Proposed Amendments to Time Synchronization Profiles

***Japan
Automotive
Software
Platform
and
Architecture***

2023.11.14

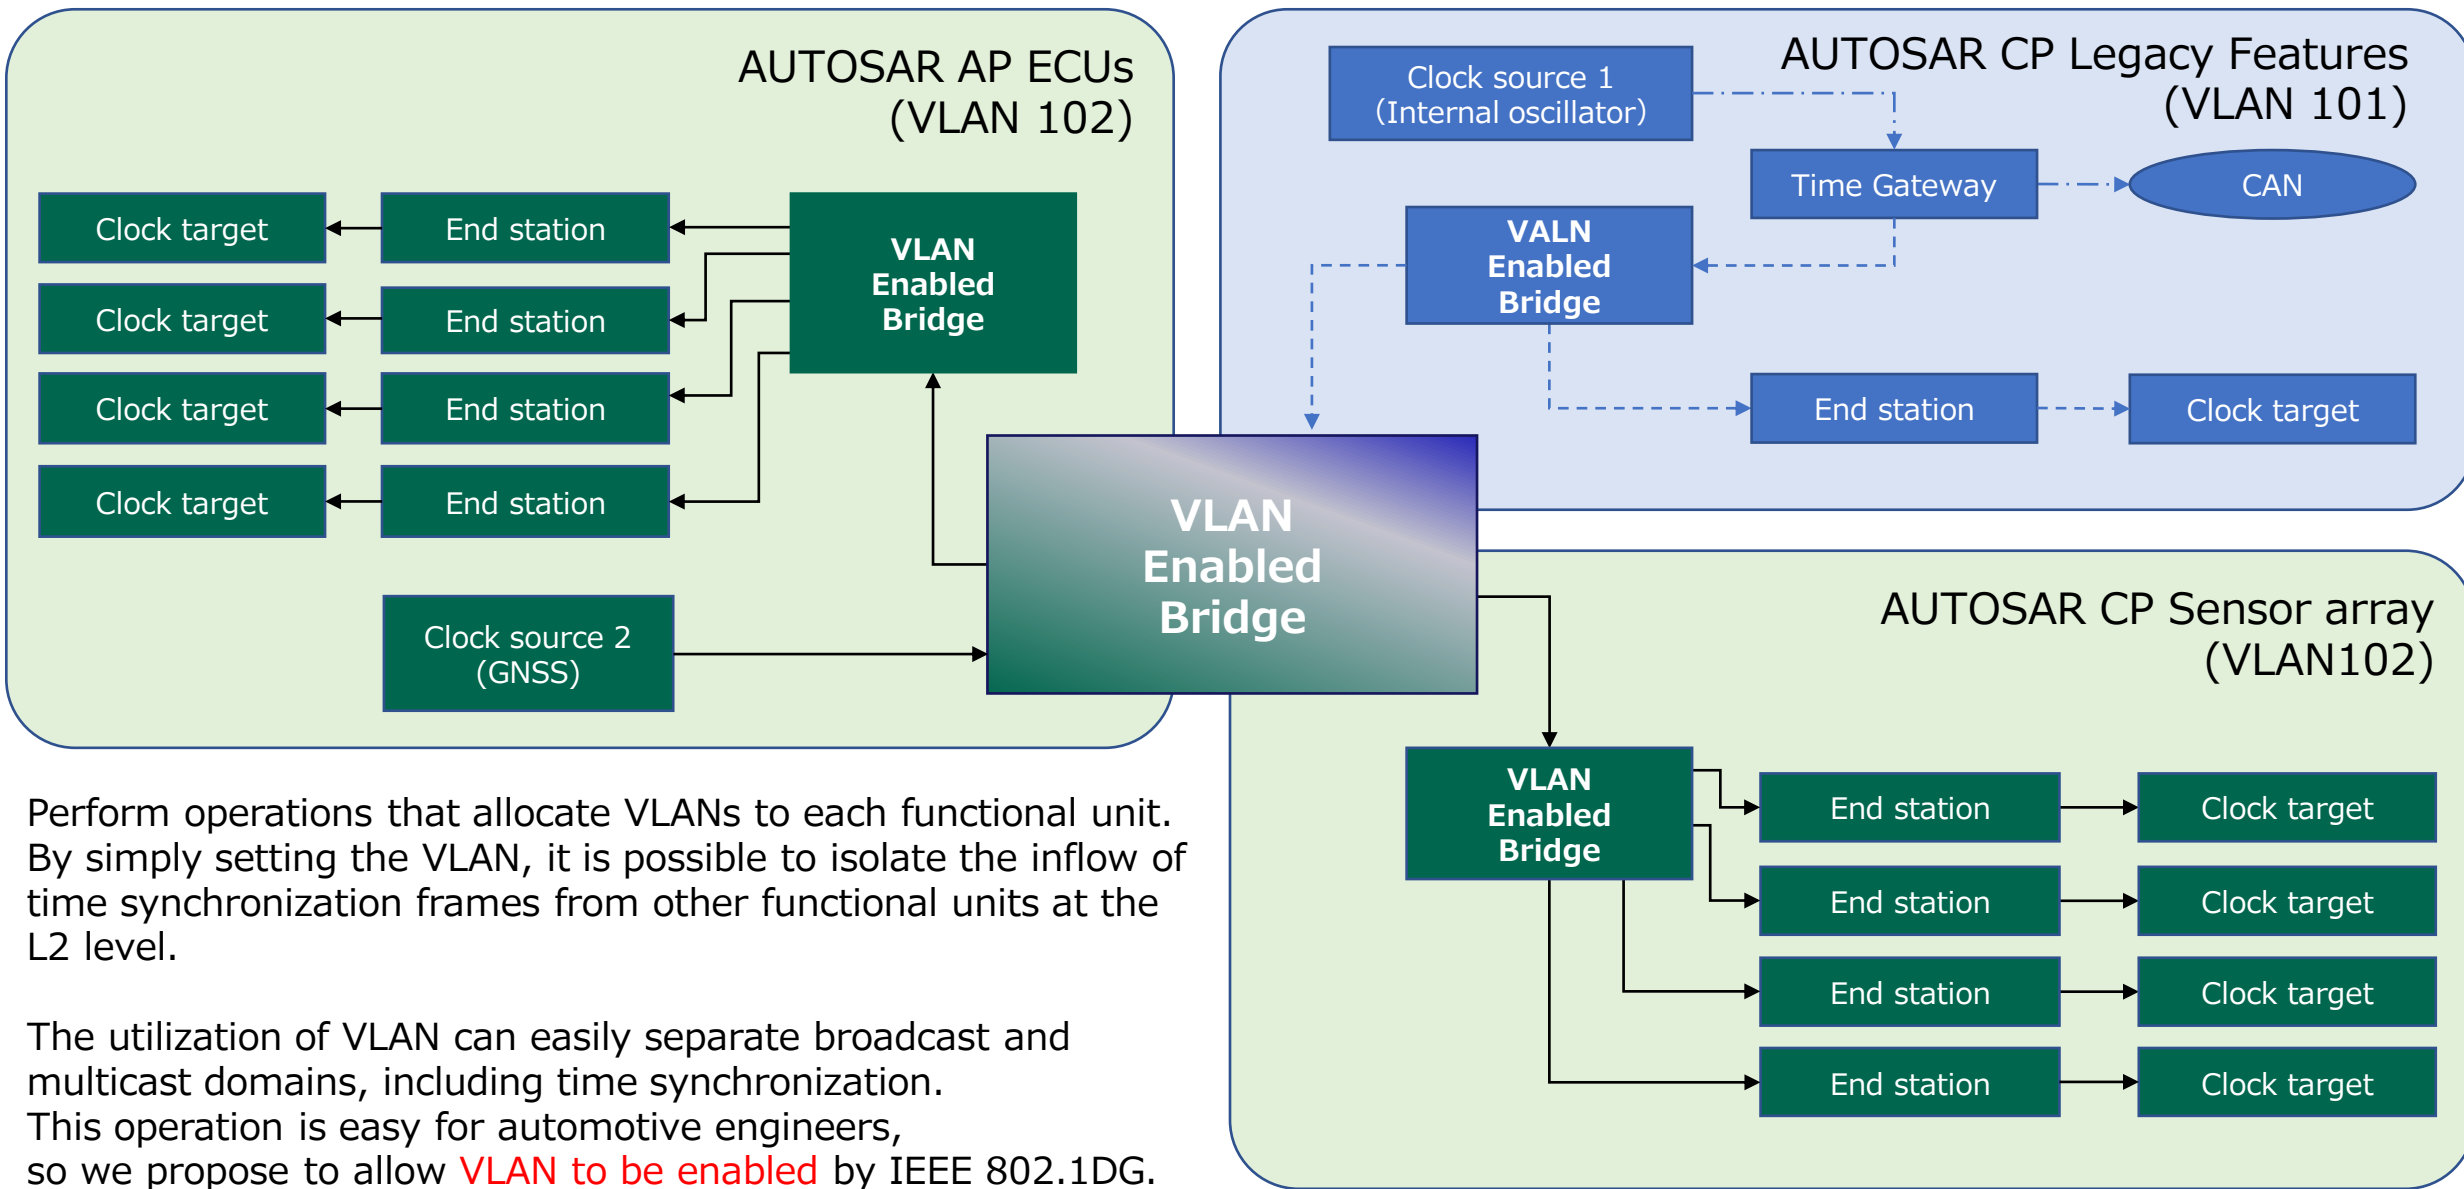
23 There are multiple specifications available to implement time synchronization (see e.g. <https://sagroups.ieee.org/1588/ptp-profiles/>). ~~It lies within the responsibility of the system integrator to ensure~~
24 ~~sufficient accuracy and traceability if needed.~~

While it is TRUE that multiple profiles exist, this description confuses most engineers. The profile should be a document that OEM and supplier engineers can understand clearly. Since suppliers refer exclusively to IEEE, **it makes sense to write in 802.1DG standard.**

② **“It lies…if needed” should be deleted.**

⇒ This is not appropriate for an automotive profile.

① **We suggest adding the following 3 items to Section 6.5**

- a) **Basically, IEEE 802.1AS-2020 compliant**
- b) **BMCA (includes Announce Message) shall not be used**
- c) **Admit All Frames (includes VLAN-tagged frames)**

⇒ This suggestion allows the specifications to be determined uniquely and can also be consistent with AUTOSAR.

Further Discussion

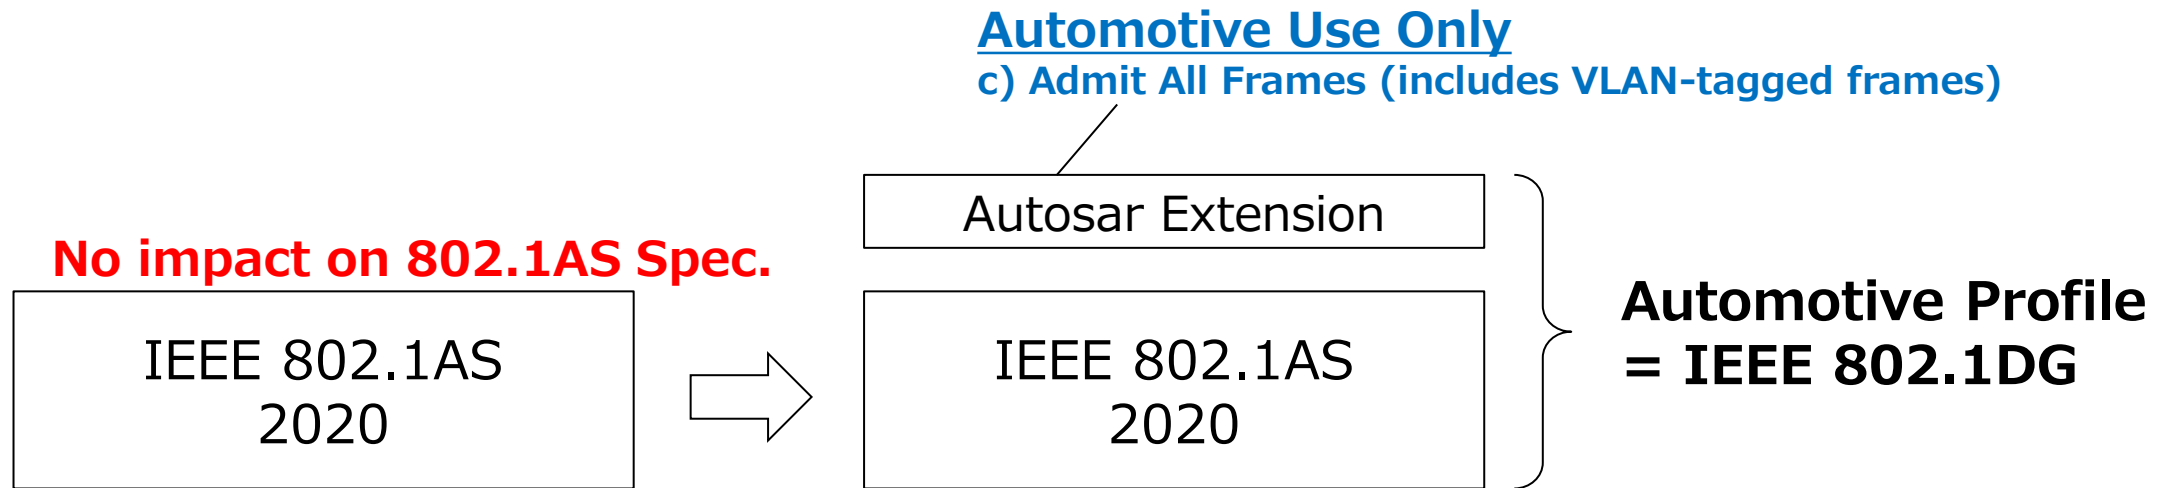
Perform operations that allocate VLANs to each functional unit. By simply setting the VLAN, it is possible to isolate the inflow of time synchronization frames from other functional units at the L2 level.

The utilization of VLAN can easily separate broadcast and multicast domains, including time synchronization. This operation is easy for automotive engineers, so we propose to allow **VLAN to be enabled** by IEEE 802.1DG.
